Access Compliance Report

Public Rights-of-Way

Intersection ID: 13743	Main Street: DR_CARVER_RD	Cross Street: WEST_BV	Location: NW
ADA ID: 2C1C764F5AA4	Ramp Type: PerpDiag	Initial Pass/Fail: Fail	Overall Compliance: No
		Severity Score: 30

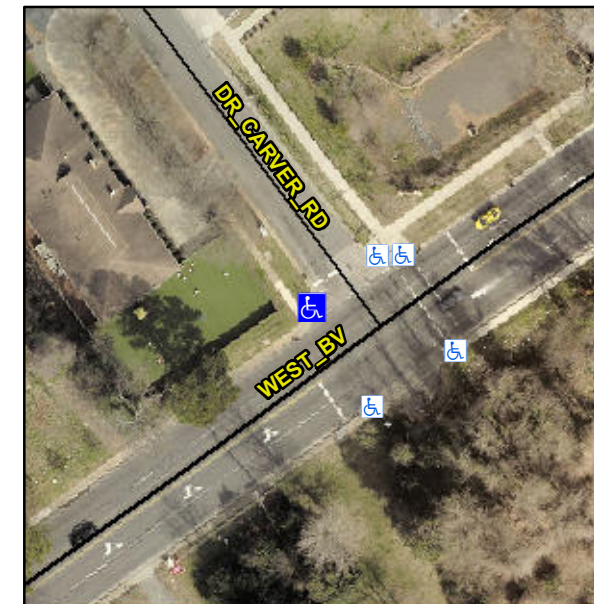
Not Found, R304.5.1, R304.2.2

Compliance	Description	Data	Compliance	Description	Data
N/A	Ramp Length (in)	47.0	No	Ramp Slope (%)	9.3
No	Ramp Width (in)	32.0	Yes	Ramp XSlope (%)	1.5
N/A	Flare Type LT	N/A	N/A	Flare Type RT	N/A
N/A	Flare Slope LT (%)	N/A	N/A	Flare Slope RT (%)	N/A
N/A	Flare Traversable LT?	N/A	N/A	Flare Traversable RT?	N/A
N/A	Landing Length (in)	N/A	N/A	DWS Provided?	N/A
N/A	Landing Width (in)	N/A	N/A	DWS Contrast?	N/A
N/A	Landing Slope (%)	N/A	N/A	DWS Length (in)	N/A
N/A	Landing X Slope (%)	N/A	N/A	DWS Full Width?	N/A
N/A	Landing Curb? (Y/N)	N/A	N/A	DWS Offset (in)	N/A
N/A	Shared Landing?	N/A			
N/A	Gutter Ponding?	N/A	N/A	Gutter Slope (%)	N/A
N/A	Gutter Lip Ht (in)	N/A	N/A	Gutter X Slope (%)	N/A
N/A	Painted X Walk1?	No	N/A	Painted X Walk2?	Yes
	X Walk 1 Direction	To S		X Walk 2 Direction	To E
N/A	X Walk 1 Width (in)	N/A	N/A	X Walk 2 Width (in)	111.0
	X Walk 1 Slope (%)	0.7		X Walk 2 Slope (%)	3.5
	X Walk 1 X Slope (%)	3.3		X Walk 2 X Slope (%)	6.5

Remove & Replace Curb Ramp With Two New Directional Ramps or Equivalent.
